# MWA Statement to Coal Authority Objection

Planning Ref: 2024 / 92031

Headlands Works, Headlands Road, Liversedge,  
WF15 7NT

Document Name: RSHR-MWA-XX-XX-RP-A-S2-PI-0001

**THE COAL AUTHORITY MAP FROM MDJA'S PHASE I DESK  
STUDY / CMRA REF: 4360 DATED FEBRUARY 24<sup>TH</sup>**

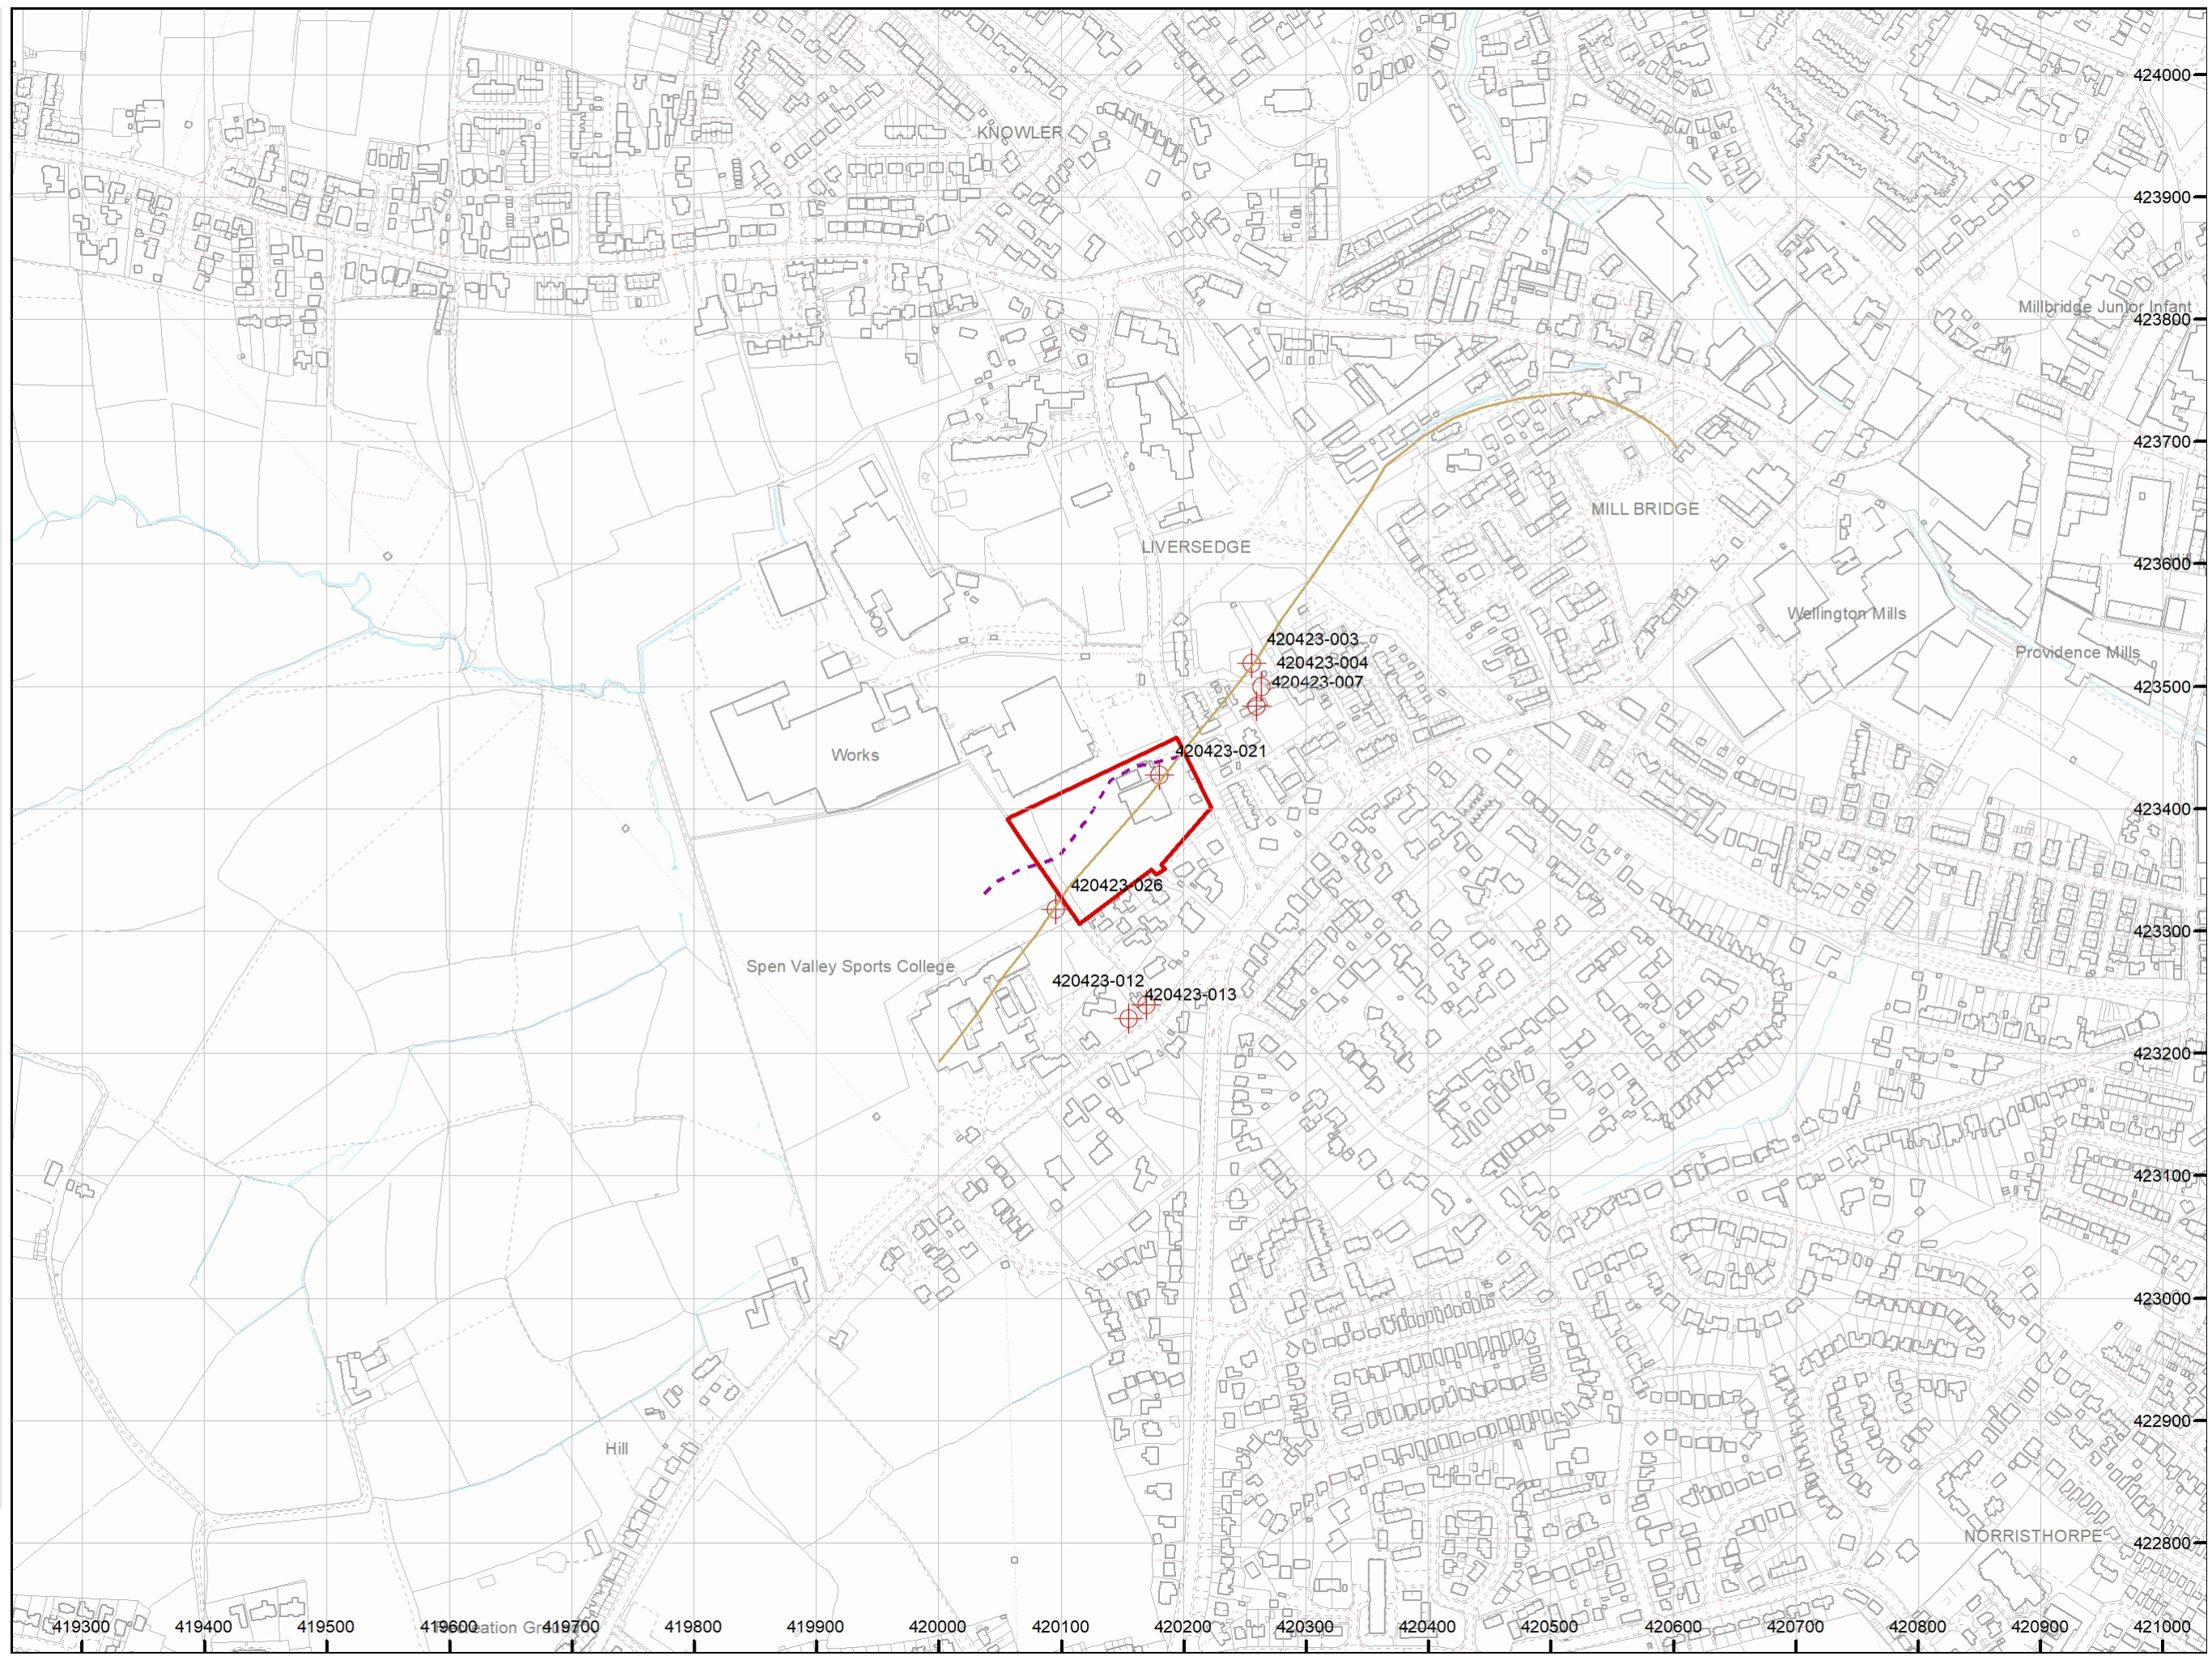
More specifically, the Coal Authority records indicate that mine shaft 420423-021 is located within the northern part of the site and that the potential zone of influence of off-site mine shaft 420423-026 may encroach into the southern corner of the site. Due to potential plotting inaccuracies, the actual positions of these former coal mining features could

**MWA DRAWING NO. RSHR-MWA-XX-XX-DR-A-  
0002\_EXISTING SITE SURVEY (REV P1) SHOWING MINE  
SHAFT POSITIONS**

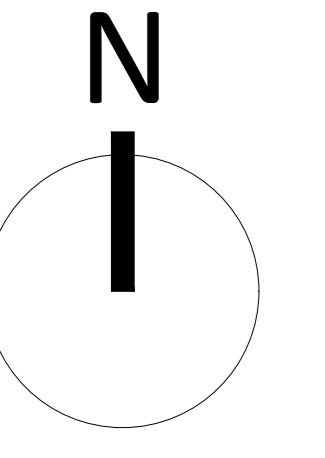
- The mineshaft is located approximately 17.2 metres from the application site boundary (Appendix 4).
- The mineshaft's approximate position is located 24 metres from the rear wall of the nearest proposed dwelling no. P23 (Appendix 5).

- The mineshaft is located in the service yard of the existing industrial complex "Headlands Works" – 5 No units (Appendix 4).
- The mineshaft's approximate position is 3.5 metres from the corner of unit 2, therefore it could actually be located under the building.

**MWA DRAWING NO. RSHR-MWA-XX-XX-DR-A-  
0003\_PROPOSED SITE LAYOUT (REV P8) SHOWING MINE  
SHAFT POSITIONS**

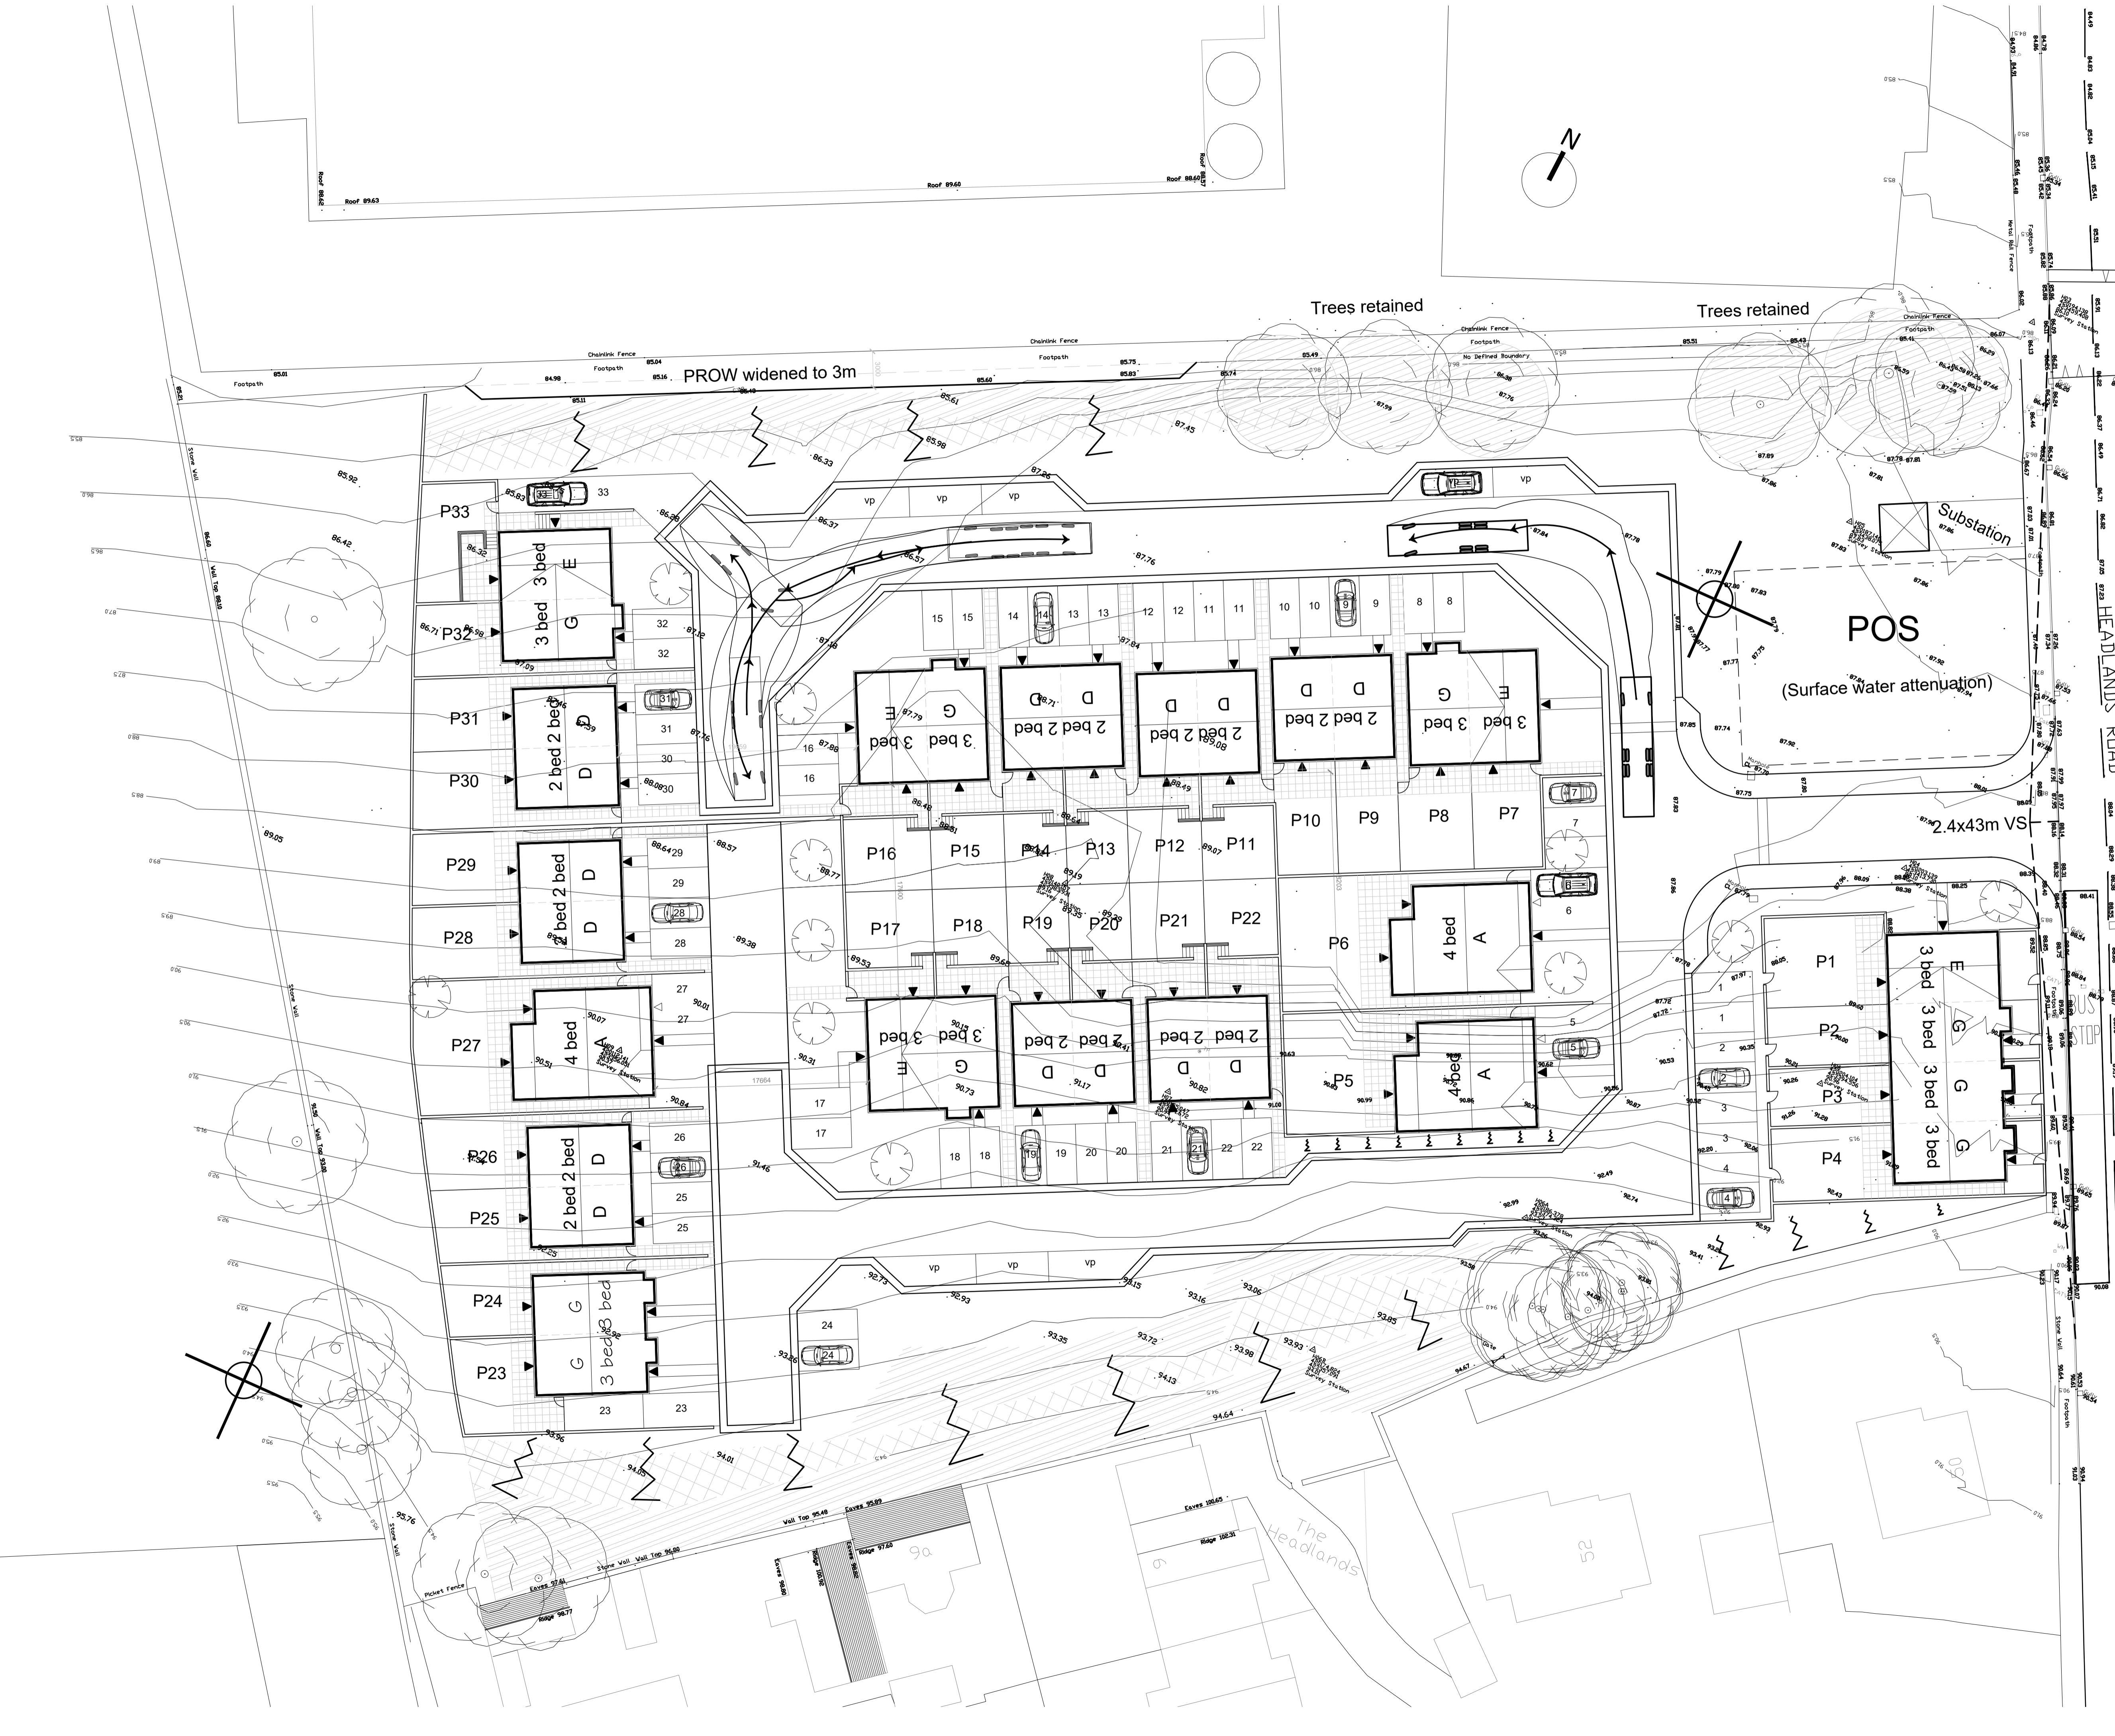
We acknowledge that the applicant is seeking outline permission for the proposed development, however, we note that they are also seeking approval of the layout of development at this stage. Whilst the recorded mine shafts and their associated zones of influence are not shown on the Proposed Site Plan, taking into account the potential departure distances for the shafts, the potential zones of influence of these features could encroach beneath the footprints of proposed built development. This would conflict with our adopted policy.

With respect to locating this shaft to the West of the application site, it is not possible to gain access to third party land but during the future site investigation works it can be established that the shaft is not located within the rear gardens of plots (p23 and p24) until the industrial complex is demolished it is impossible to gain access for machinery to the area due to the existing units, trees and steep topography of the site.

The information gained from these site investigations will enable the position of the on-site shaft to be identified and the extent of the zone of influences of this shaft and the off-site shaft to be calculated. This will allow any necessary revisions to be made to the site layout to ensure that the built development is sited in a manner which avoids the shafts and their zones of influence. These details should be clearly shown on a revised Proposed Site Layout drawing.
